Mercedes-Benz

Campaign No. 2019090019, October 2019

SUBJECT: **Model CLS-Class vehicles (257 platform)**
Model Year 2019
Wiring Harness for Electric Coolant Pump

Figure 1

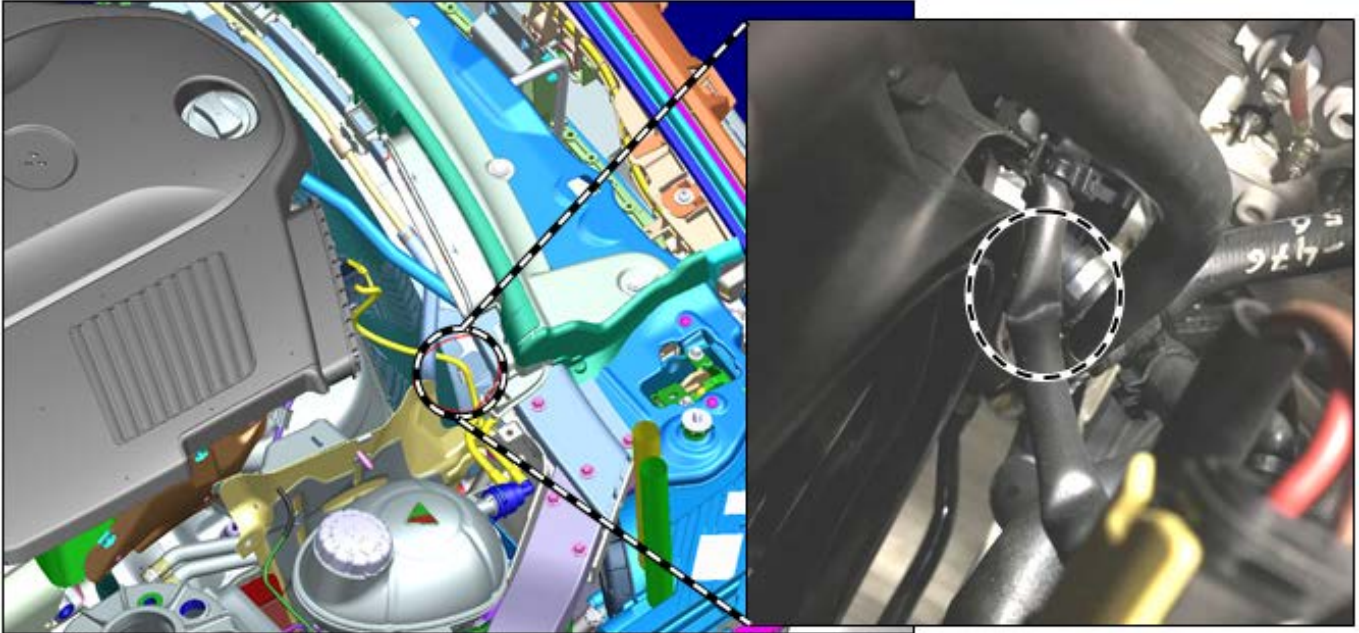
1. Check electrical wiring harness of electric coolant pump in area of fan for damage (figure 1).

- a. **Line insulation and protective hose of electrical wiring harness damaged:**
Perform **work procedures A and B and C.**
- b. **Only Protective hose of electrical wiring harness damaged and line insulation NOT damaged:**
Perform **work procedures B and C.**
- c. **Line insulation and protective hose of electrical wiring harness Both NOT damaged:** Perform **work procedure C.**
